1096 WEST BROADWAY (COMPLETE APPLICATION)
DE411434 - ZONE C-3A

DEVELOPMENT PERMIT STAFF COMMITTEE MEMBERS

DEVELOPMENT PERMIT STAFF COMMITTEE RECOMMENDATION: APPROVE

Figure 1

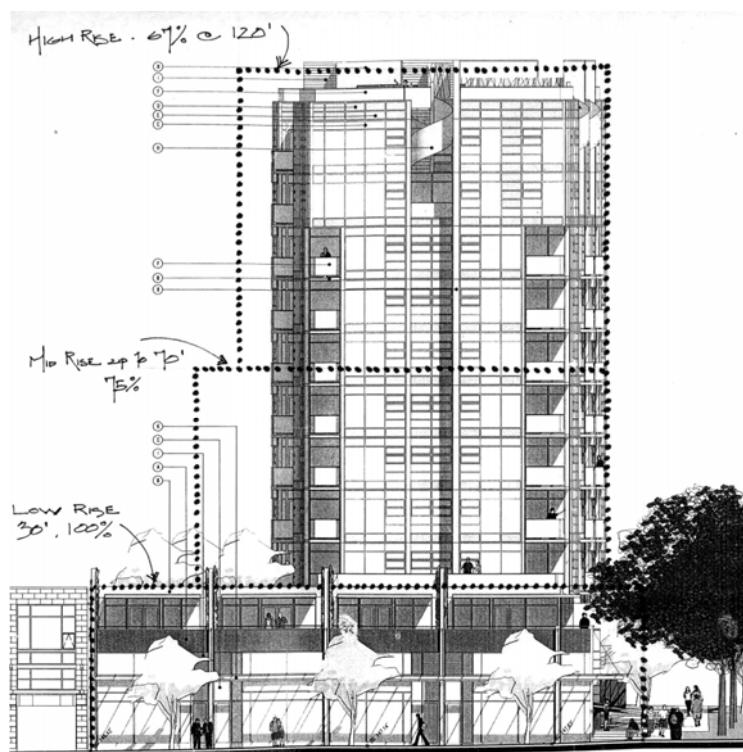
Figure 1, shows a comparison between the proposed building and suggested Guideline massing. This illustrates that the proposed building is significantly slimmer in both the mid-rise and high-rise portions of the building than what the Guidelines recommend. This slimmer tower form has the positive effect of both reducing shadows on the street and improving sun access and views through the site.

The Guidelines recommend a continuous base height of 30 ft. along the retail street frontage to give pedestrian scale and a sense of street enclosure. The low rise massing along Broadway is 30 ft. and continuous across the street frontage, up to a 9 ½ ft. exterior sideyard at the corner of Spruce Street. This 9 ½ ft. setback is supported by staff for the benefits of an expanded public realm. (See Figure 1) The second floor residential units facing Broadway step back from the street edge to provide a private outdoor amenity space and buffer to the street. The continuity of the 30 ft. high building envelope is achieved with vertical privacy walls, horizontal stone banding and prominent roof overhangs. The Urban Design Panel agreed these elements reinforced the desired 30 ft. high scale at the street edge, but thought the deep roof overhangs and stone banding would negatively affect livability by restricting natural light access into these north facing units. (See further discussion on livability page 9 and 10 and Condition 1.1)
